Subject: Northern Integrated Supply Project, Supplementary Draft Environmental Impact Statement, Comments by Trout Unlimited

NISP SDEIS Technical Review

Figure A1. Example figure of box and whiskers of monthly average streamflow.

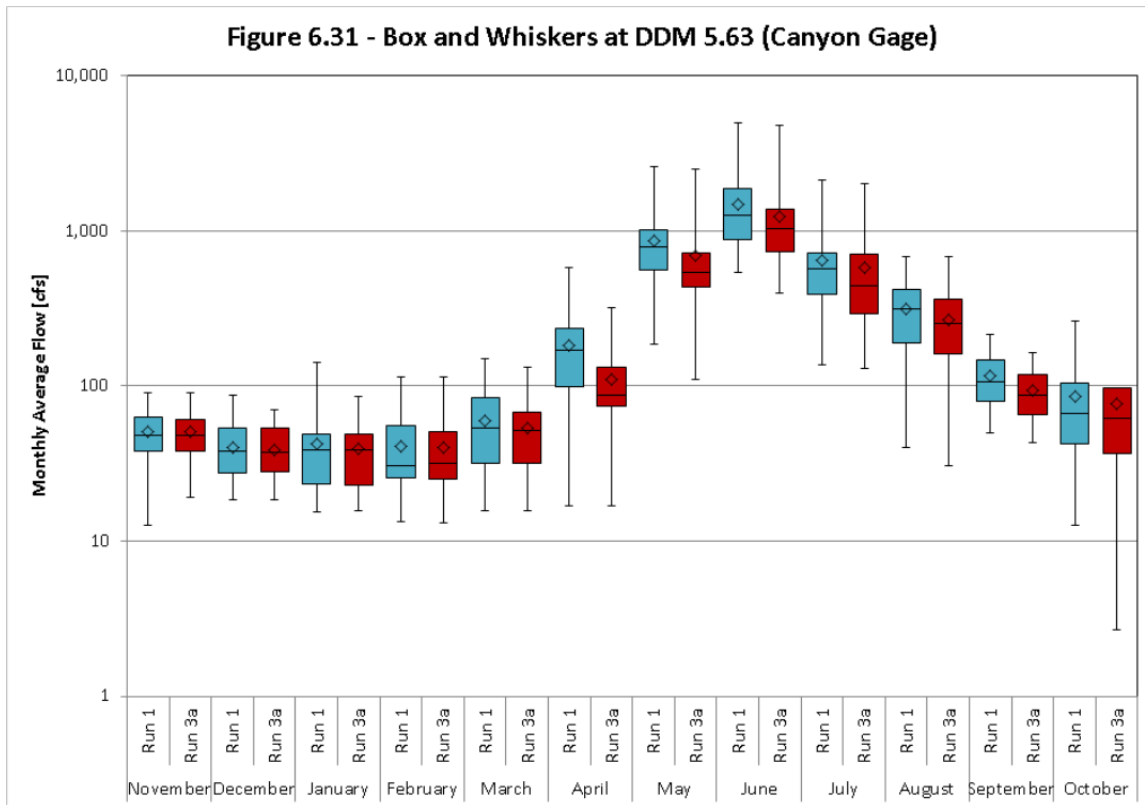
The figures of statistical distributions (i.e. minimum, maximum, mean and quartiles) of the *mean monthly* streamflow for the 1950-2005 current conditions (e.g. WRTR Figure 6.31; Appendix A Figure A1) do not provide any information appropriate for understanding environmental impacts because the data just show effects on an increasingly averaged streamflow condition (i.e. because monthly streamflow is already an average of streamflow for all days of the month, the data show the mean of a mean). It is uninformative to show effects of the alternatives on the *mean* or *median* streamflow, whether at a monthly or daily timestep. The data need to show effects on the *minimum* and *maximum daily* streamflows, where fish habitat and stream temperature will be most impacted by the alternatives.

Figure A2. Example figure of median daily streamflow.

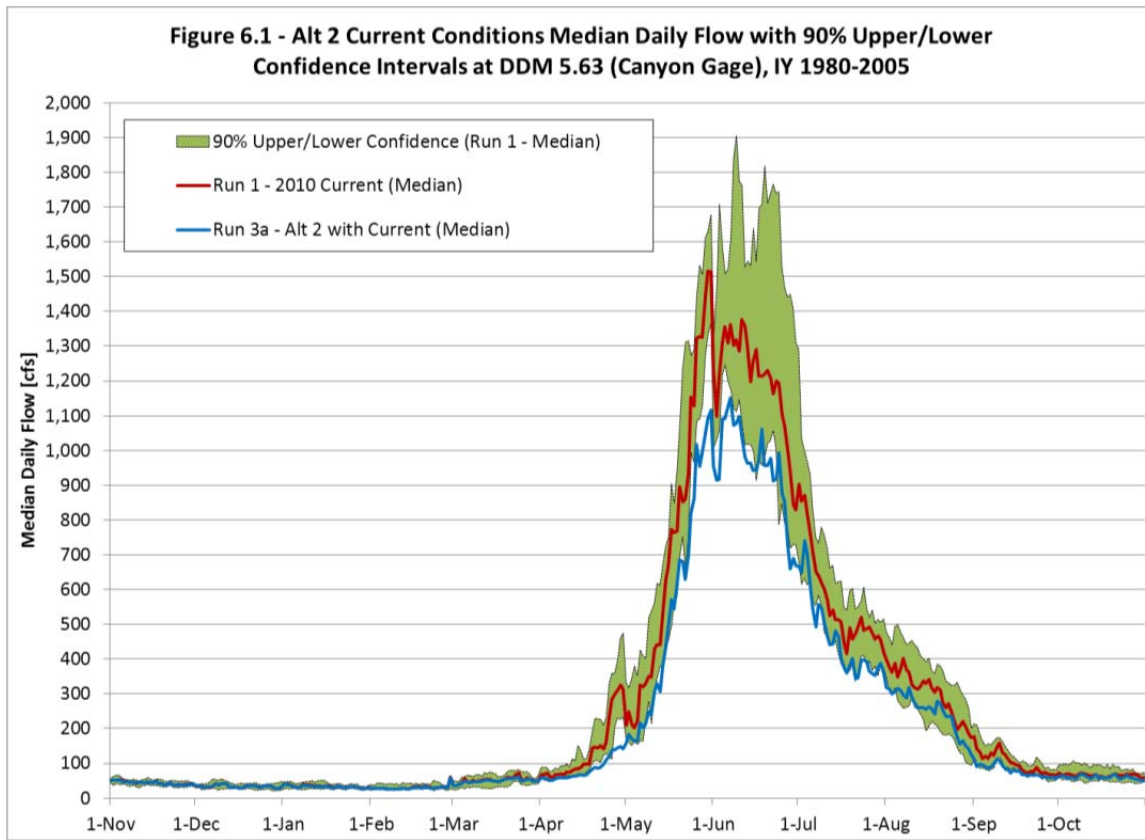
The figures of time series of the median daily streamflow (e.g. WRTR Figure 6.1; Appendix A Figure A2) are more informative, but are still unsatisfactory because, even though presented at a daily timestep, they still just show effects on an averaged streamflow condition. Moreover, it is not justifiable to infer, as implied by these figures, that impacts of an alternative are not significant if the median daily streamflow for an alternative is within the 90% confidence interval of the historical median. Although an alternative may not substantially change the median daily streamflow, the minimum and maximum daily streamflows can be changed quite considerably.

Figure A3. Example figure of statistical summary of daily streamflow.

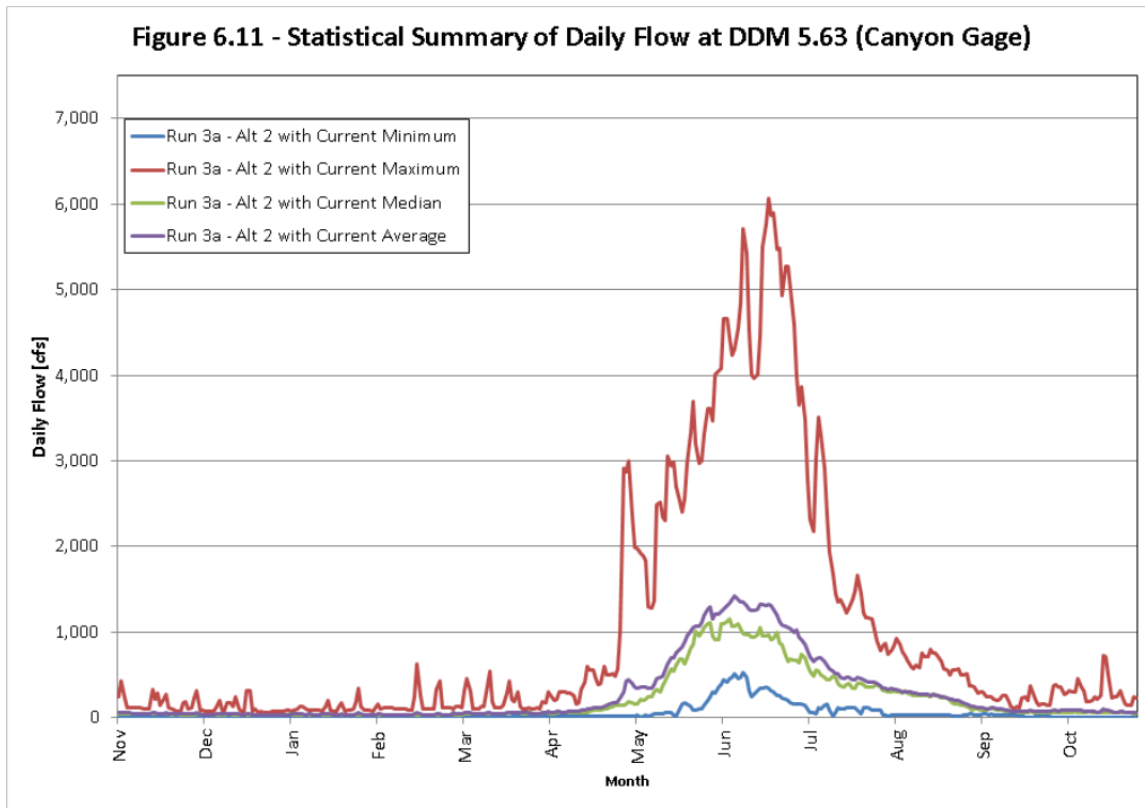
- Where the most meaningful information is presented with maximum, mean, median and minimum streamflows (e.g. WRTR Figure 6.11; Appendix A Figure A3), the y-axis is presented on an arithmetic scale rather than a logarithmic scale – making it difficult to discern impacts on the minimum daily streamflow (where particularly important impacts on fish and other aquatic life, as well as stream temperature, are most likely to occur). Moreover, figures should be presented to compare these measures for alternatives against the current conditions rather than on separate graphs. The Corps should add to its presentation of surface water impacts the changes in minimum and maximum daily streamflows relative to current conditions – i.e., graphed as a percentage change from current conditions.

The figures of time series of the maximum, mean, median and minimum daily streamflows (e.g. WRTR Figure 6.11; Appendix A Figure A3) are most informative, but unfortunately they have a y-axis graphed on an arithmetic scale (i.e. the scale is too constricted toward zero), instead of graphed more reasonably

Figure A4. Example figure of daily streamflow duration curve.

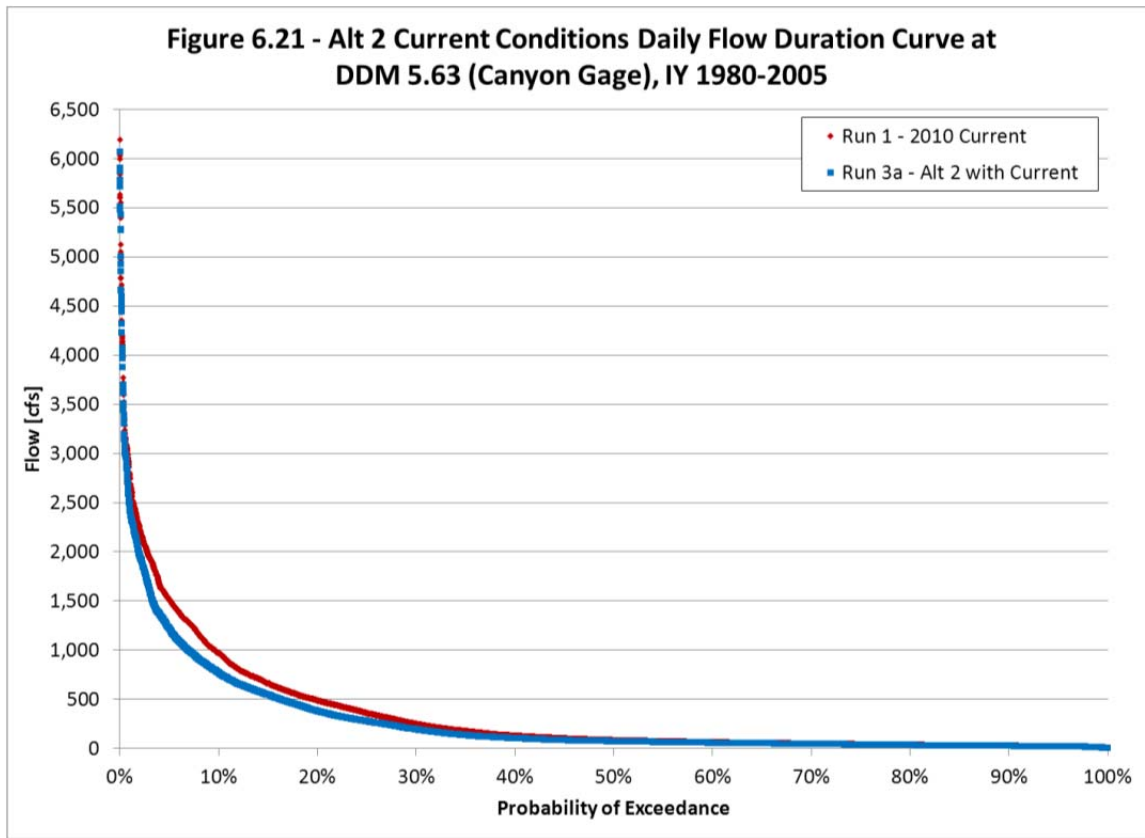
- Figures for streamflow duration curves (e.g. WRTR Figure 6.21; Appendix A Figure A4) also do not have a y-axis graphed on a logarithmic scale, as is the scientific norm – making it difficult to distinguish the effects of alternatives of streamflow at the highest and lowest exceedance probabilities. Again, impacts on these extremes may be highly significant for aquatic resources – but the current presentation tends to obscure the impacts of the alternatives on the extremes.

The figures of duration curves for daily streamflow (e.g. WRTR Figure 6.21; Appendix A Figure A4) also do not have a y-axis graphed on a logarithmic scale, as is the scientific norm. Therefore, effects of the alternatives on daily streamflow at the highest and lowest exceedance probabilities cannot be distinguished, and impacts on flow-related resources, like fish habitat, will be greatest at these extreme maxima and minima. However, important information on the annual sequence of high and low streamflows is also lost by ranking streamflows as exceedance probabilities in flow duration curves.

Figure B2. Figures of DM (top) and MWAT (bottom) temperature excursions at the canyon mouth gage in coldwater Segment 10.

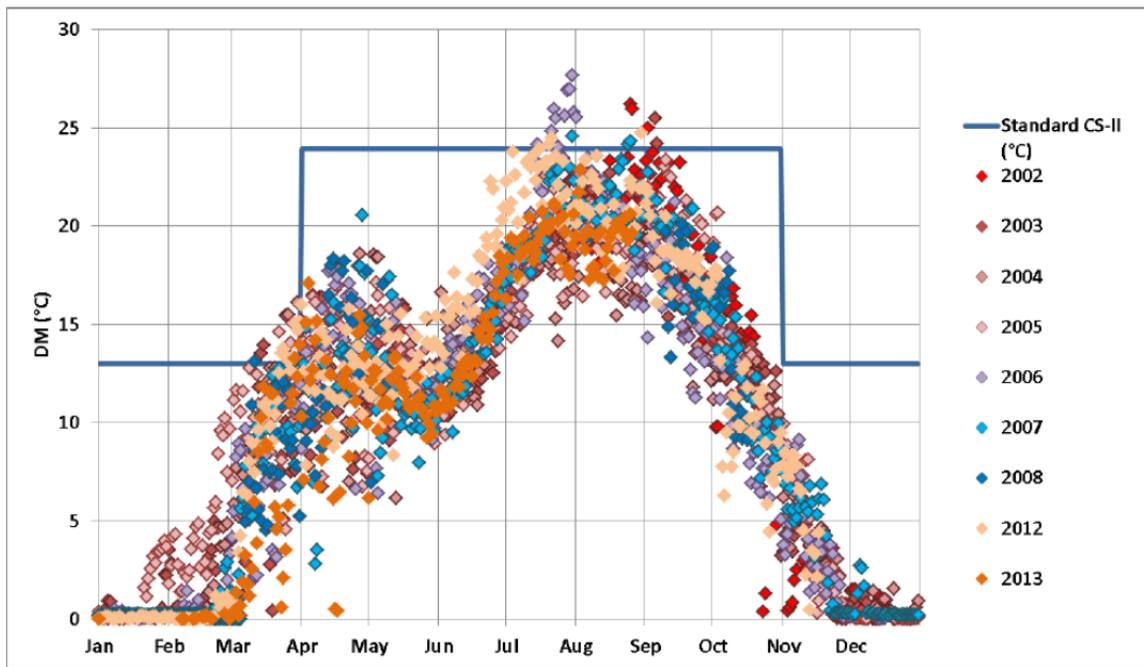
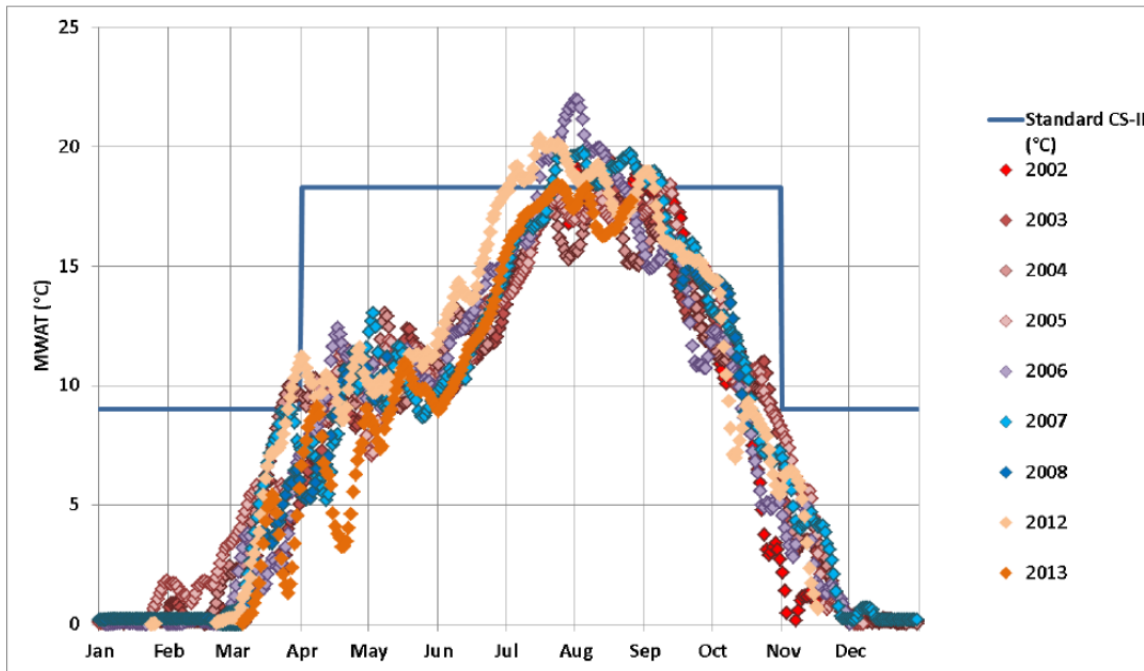
Coldwater Segment 10 has exceeded the summer DM standard of 23.9°C in July and August in at least five years at the Canyon gage (STDOA Appendix A Figure 1; Appendix B Figure B2), and in at least one year (and very nearly in three other years) at the Hansen gage (STDOA Appendix A Figure 3; Appendix B Figure B3). The winter DM standard of 13°C has also been exceeded in March in at least four years at the Canyon gage, and in at least two years at the Hansen gage. These exceedances have been on as many as ten consecutive days and by as much as 5°C. Coldwater Segment 10 has also exceeded the summer MWAT standard of 18.3°C in July and August in at least six years at the Canyon gage (STDOA Appendix A Figure 2; Appendix B Figure B2), and in at least four years at the Hansen gage (STDOA Appendix A Figure 4; Appendix B Figure B3). The winter MWAT standard of 9°C has also been exceeded in March in at least three years at the Canyon gage, but in no years at the Hansen gage. These exceedances have been on as many as 50 (perhaps even more) consecutive days and by as much as 5°C. Exceedances at the Hansen gage would likely have been more similar to those at the Canyon gage, but data for just years 2007-2013 were available for the Hansen gage compared to 2002-2013 for the Canyon gage.

Figure B4. Figures of DM (top) and MWAT (bottom) temperature excursions at the gage downstream of Boxelder Creek in warmwater Segment 11.

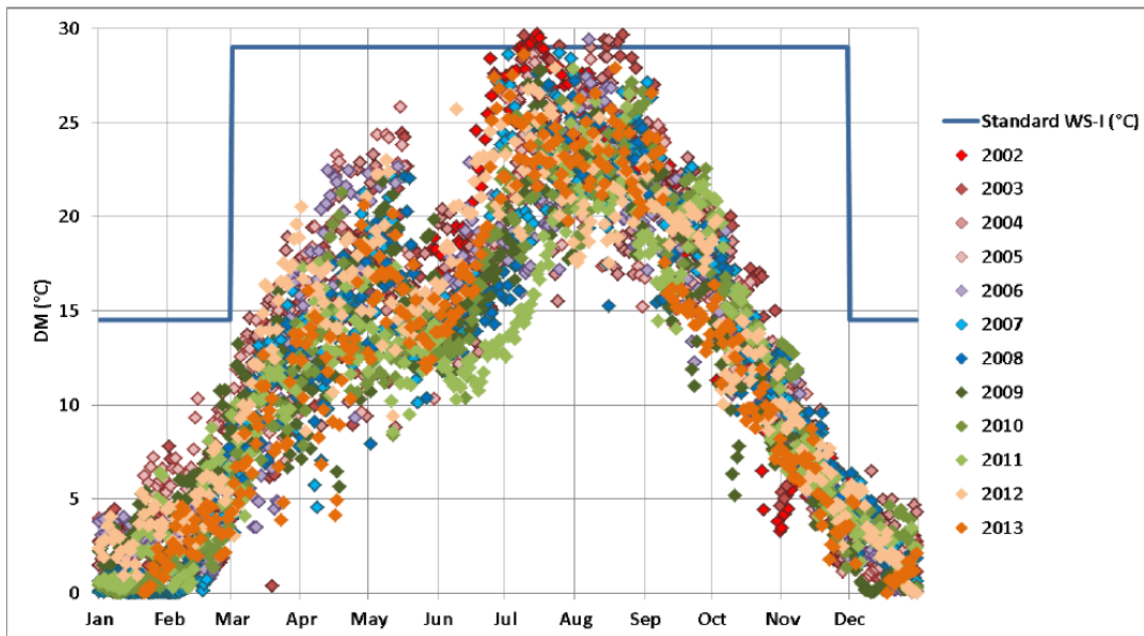
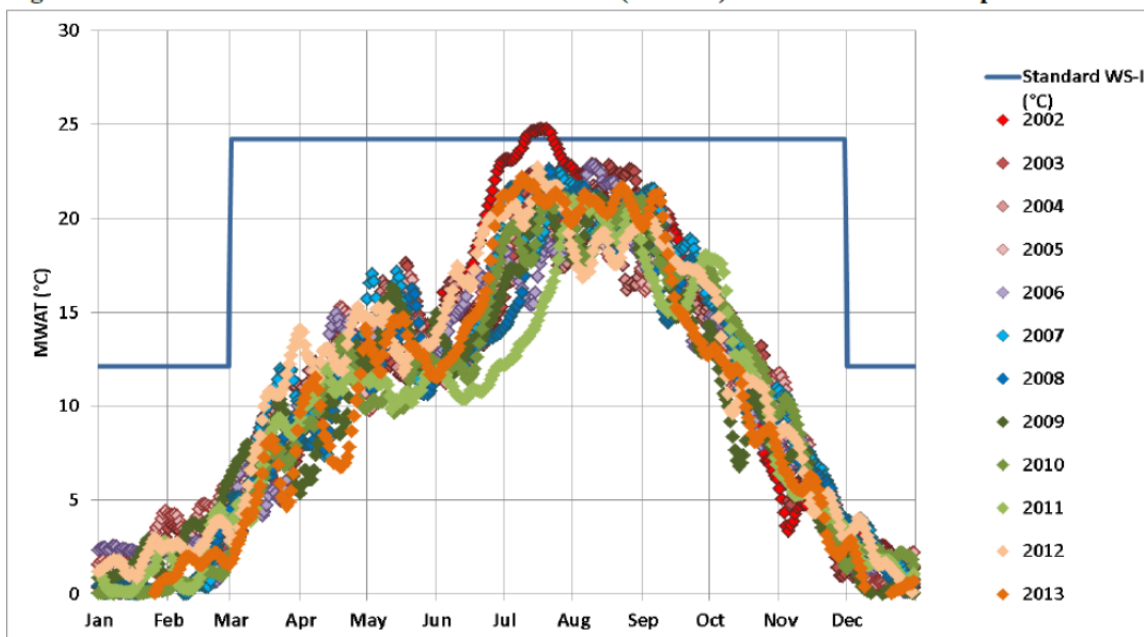
Warmwater Segment 11 has exceeded the summer DM standard of 29°C in July and August in at least five years (and very nearly two other years) at the Boxelder gage (STDOA Appendix A Figure 19; Appendix B Figure B4), and Segment 12 very nearly in one year (and within 1°C in another year) at the Fossil gage (STDOA Appendix A Figure 23; Appendix B Figure B5). These exceedances have been on as many as five consecutive days and by as much as 1°C. The winter DM standard of 14.5°C has not been closely approached in any years at the Boxelder gage or the Fossil gage. Warmwater Segment 11 has also exceeded the summer MWAT standard of 24.2°C in July and August in one year (and within 1°C in at least seven other years) at the Boxelder gage (STDOA Appendix A Figure 20; Appendix B Figure B4), and Segment 12 in very nearly one year (and within 0.5°C in three other years) at the Fossil gage (STDOA Appendix A Figure 24; Appendix B Figure B5). The winter MWAT standard of 12.1°C has not been closely approached in any years at the Boxelder gage or the Fossil gage. These exceedances have been on as many as 10 consecutive days and by as much as 1°C. Because data just for years 2004-2013 were

Figure C1. Example figure of habitat availability time series for the preferred alternative for adult brown trout in Segment A.

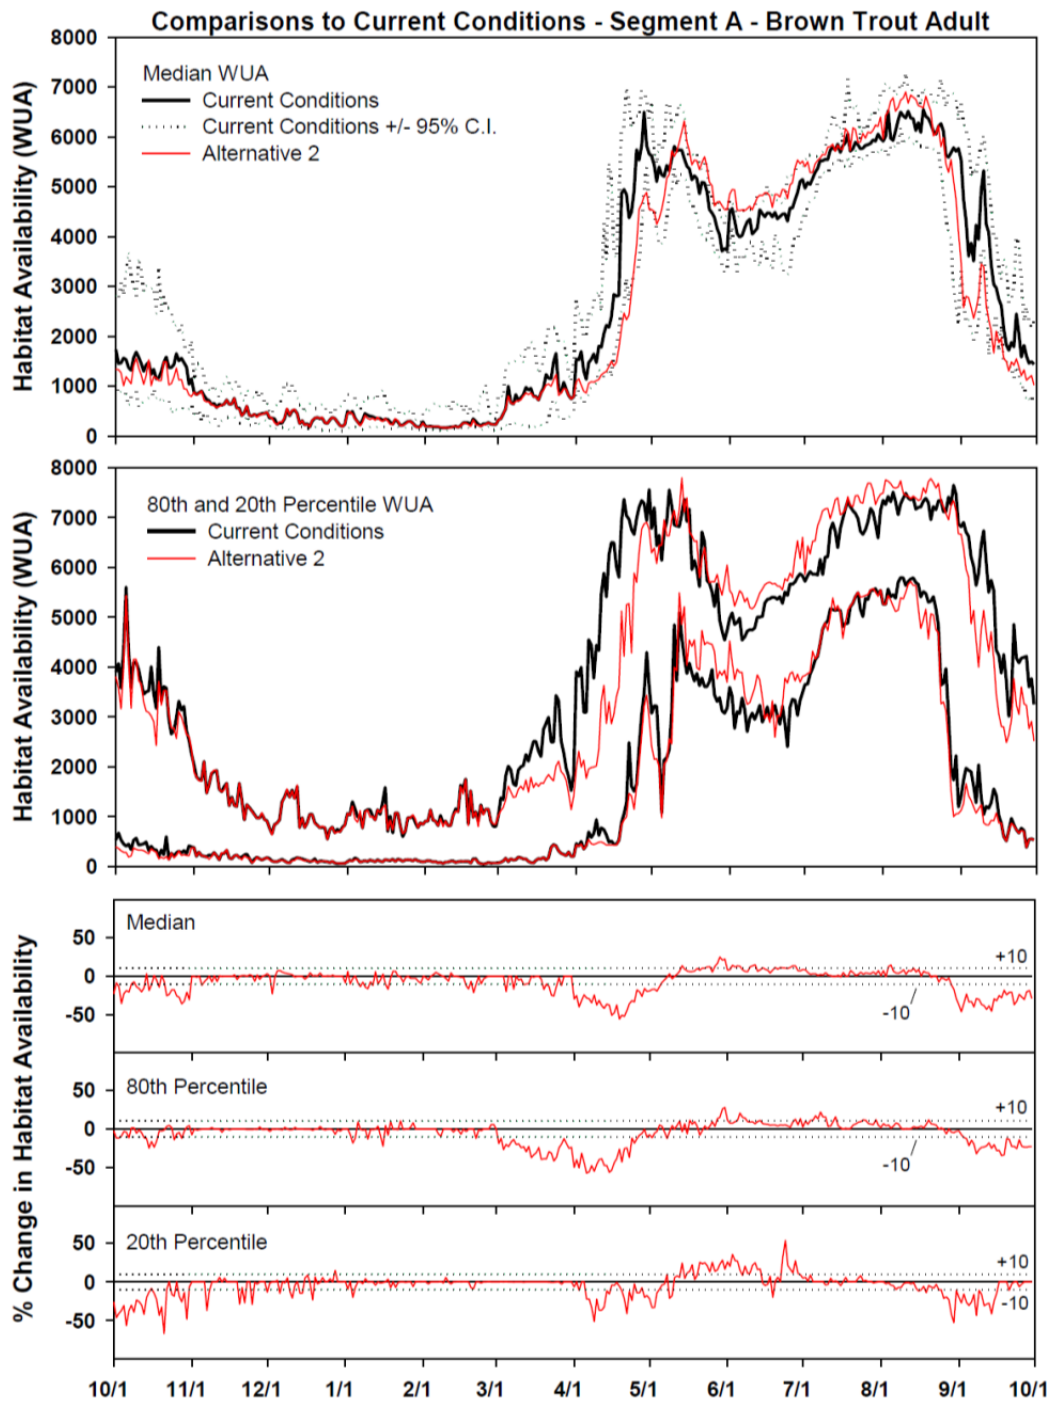
Although the figures need to present data that show WUA in real streamflow years instead of artificial WUA years, data showing WUA in *median* streamflow years would be as uninformative as showing effects of the alternatives on the median streamflow, which was discussed in some detail in the section on surface water. The data need to show effects on WUA in the *minimum* streamflow year, when fish habitat will likely be most impacted by the alternatives. The figures in the technical report present data on WUA in the 20th percentile WUA year, but the 5th percentile streamflow year would be more appropriate for understanding impacts of the alternatives on fish habitat toward the minimum extreme of the statistical distribution of streamflows. However, probably most judiciously, effects of the alternatives on fish habitat need to be analyzed for the percentile streamflow year(s) where streamflows are most impacted by the alternatives. Furthermore, it is not defensible to infer, as intended with these figures, that impacts of an alternative are not significant if WUA in the median year for an alternative is within the 95% confidence interval of the historical median. Although an alternative may not substantially change WUA in the median year, WUA in the minimum and maximum years can be changed quite considerably.
